Brisbane Central Business District Bicycle User Group

I refer to your letter dated 12 September 2019 responding to the negative issues the Brisbane CBD BUG has sought to have addressed in relation to the shared path through the Howard Smith Wharves (HSW) precinct.

Figure 1 – Guideline for shared or segregated paths

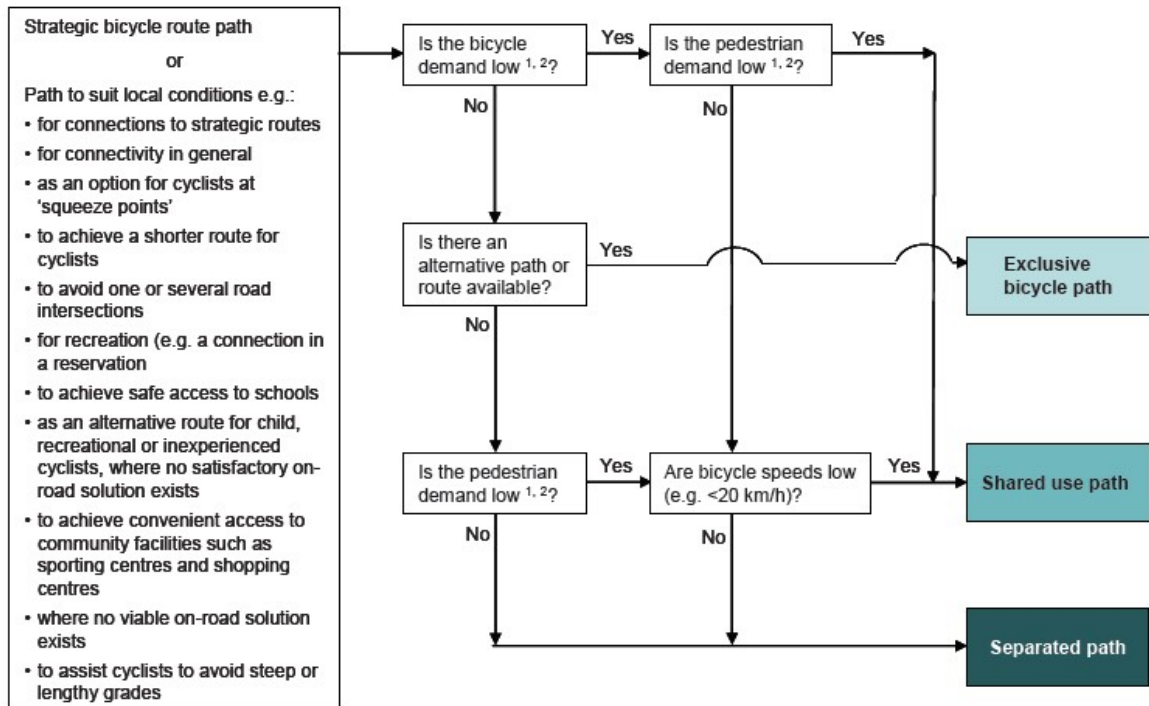
We also note your statement that HSW “has worked with industry leading experts to deliver the shared pathway, which complies with all relevant standards”. Sadly though, in our view the HSW path does not comply with AustRoads “Guide to Road Design part 6A: Pedestrian & Cyclist Path” (2009). While not a mandatory standard it is certainly a “relevant” document when providing a shared path (Figure 1).

FIGURE 1

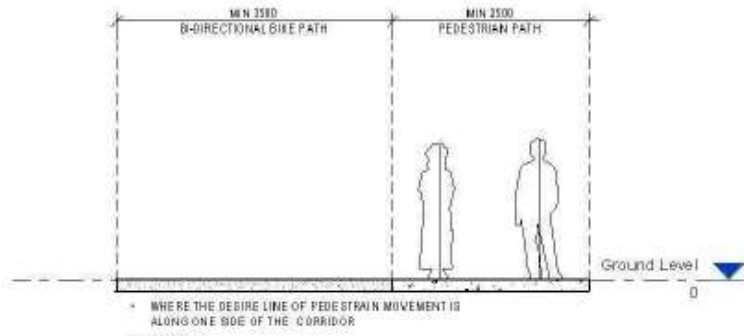
1. Segregation – As a shared facility the current path is less than ideal due to the potential for conflicts between pedestrians and cyclists, particularly during the peak travel periods. The CBD BUG welcomes the indication that the new facility will be segregated in a similar manner to the recently constructed Riverwalk. It is suggested that due to traffic volumes the minimum cycling path width of 3.5m be designed for. For further detail see Figure 1 and Figure 2
